**From:** "Blickwedel, Roy (GE, Corporate)" <Roy.Blickwedel@ge.com>  
**To:** "Paul Michalak (E-mail)" <PXM2@nrc.gov>  
**Date:** 12/01/2006 4:35:38 PM  
**Subject:** Church Rock Fact Sheet - *Docket 40-8907*

**UNITED NUCLEAR  
CORPORATION  
(MCKINLEY COUNT  
NEW MEXICO**

**Updated: November 2006**

## Site Map

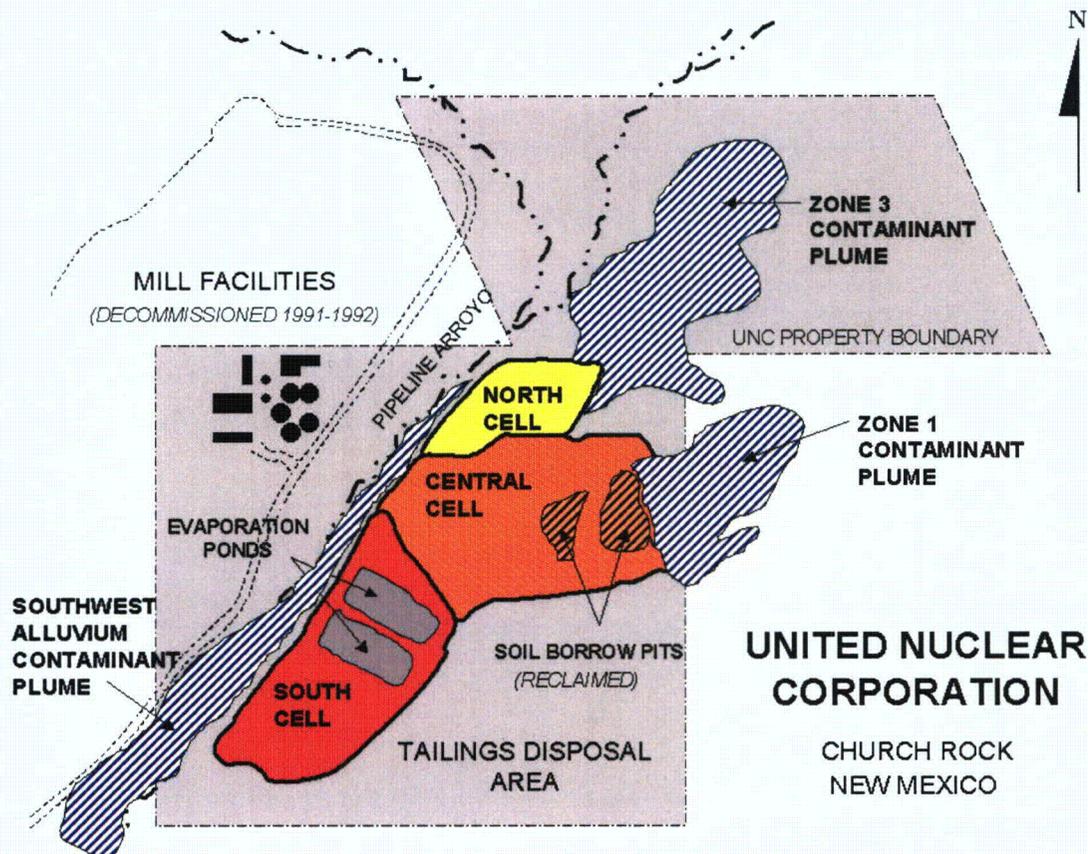
Except for the tiniest bit of impacted groundwater that extends onto Section 1 (less than the area depicted, see Fig. 57 of the most recent Annual Report), hazardous constituents are entirely contained within lands that UNC holds title to. Similarly, the offsite SWA plume is not a contaminant plume in the classic sense - rather the seepage-impacted water (that does not contain hazardous substances above any standard) only contains elevated alkalinity, which is harmless and which actually goes to prove that hazardous substances are attenuated onsite. In the last update EPA used the term "seepage area" instead of "contaminant plume", but they have unfortunately not followed suit this time or sought our input.
